UNITED STATES PATENT AND TRADEMARK OFFICE

10/773,033

Office Action Summary	Application No. 10/773,033	Applicant(s) MOON ET AL.	
	Examiner Timothy M. Ayres	Art Unit 3637

DETAILED ACTION

Hsu '759 Figure 1

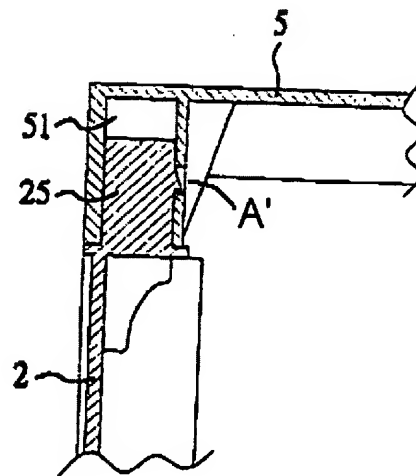
11. Claims 1, 2, 11-16 are rejected under 35 U.S.C. 103(a) as being unpatentable over US Patent 6,474,759 to Hsu in view of US Patent 4,193,649 to Sharon. Hsu teaches a plastic cabinet that can have drawers as seen in figure 11. The cabinet is made up of a base panel (1), top panel (5), left side panel (2), right side panel (3), and back panel (4). The top and bottom panels (1,5) connect to the side and back panels (2,3,4) with a means for attaching (11, 12 ,51, 21,25,41,42,31,35). The means for

attaching (11, 12, 51, 21, 25, 41, 42, 31, 35) is posts (35, 42, 25, 21, 31, 41) on the side and back panels (2, 3, 4) that have integrally formed spring tabs (A') that communicate with locking sockets (11, 12, 51) in the base and top panels (1, 5) as seen in figure 1 and 7 below.

Hassel '874 Figure 5

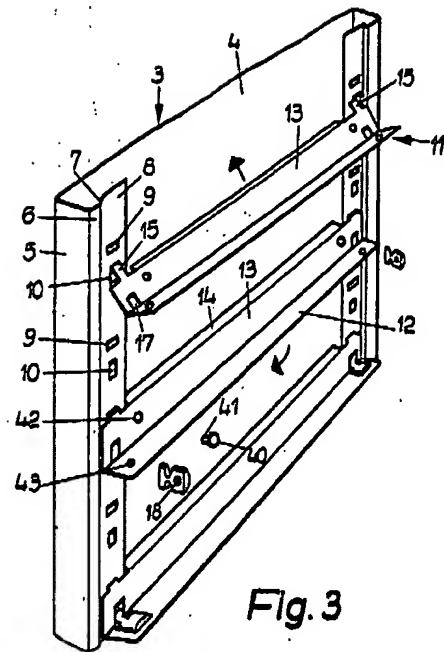
16. Hassel teaches a cabinet (1) with drawers (2). The drawer glides (11) are mounted with locking posts (16,15) that have a conjugate shape and extend through apertures (9) in integral vertical rail (8) that are formed on the side wall (3). The drawer glides (11) are L-shaped with a vertical leg (13) and horizontal leg (12). The drawers (2) have slides (34,35) and the rear portion of the drawer (2). A locking member (18) extends through an opening (17) in the vertical leg (13) of the drawer glide (11) and an aperture (10) on the vertical rail (8) to secure the drawer glide (11) in place. The upper slides (35) contact the bottom of the drawer glide (11) that is above the drawer (2) and the lower slides (34) on the drawer (2) contact a drawer glide (11) that is relatively level with the drawer (2).

Hassel '874 Figure 3

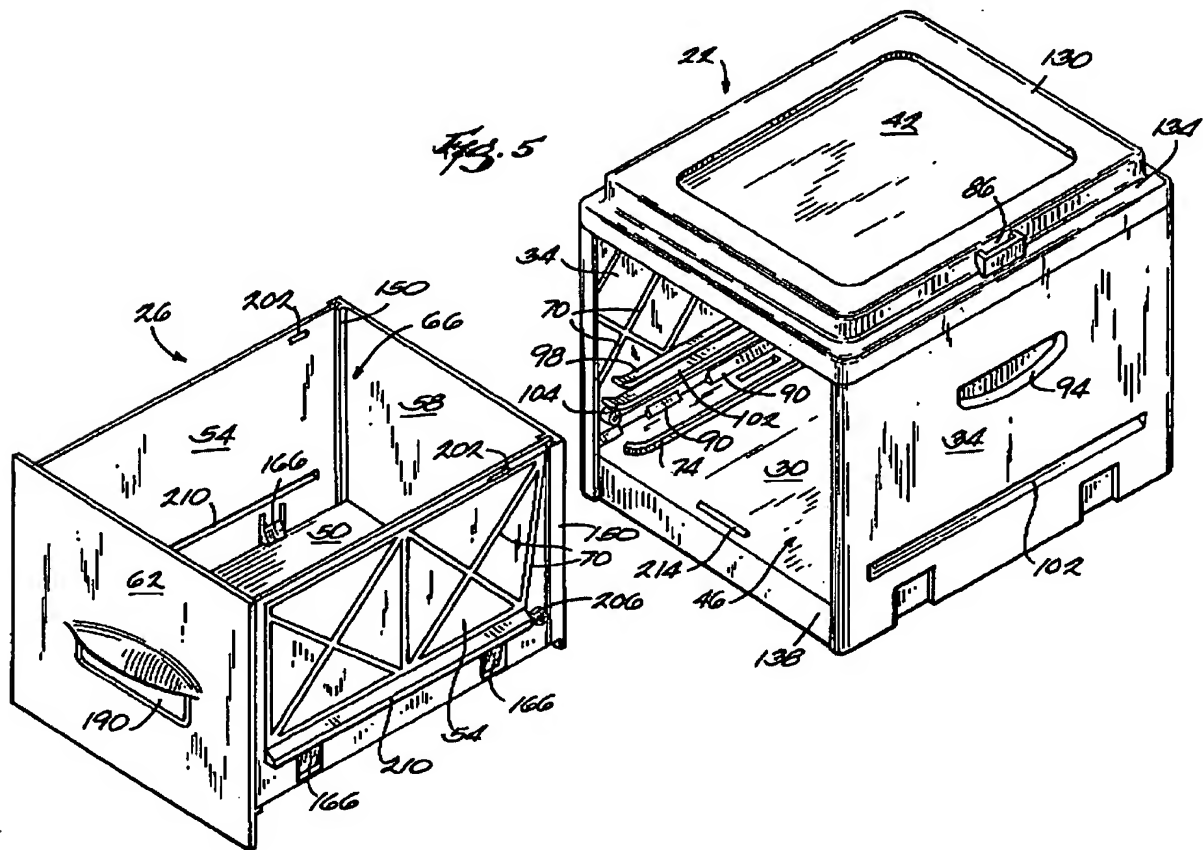
17. At the time of the invention it would have been obvious for a person of ordinary skill in the art to modify the cabinet of Hsu by having the drawer slide assembly as taught by Hassel so that the drawer glides can be attached to the cabinet quicker and easier (Hassel '874, Col. 1, lines 10-14).
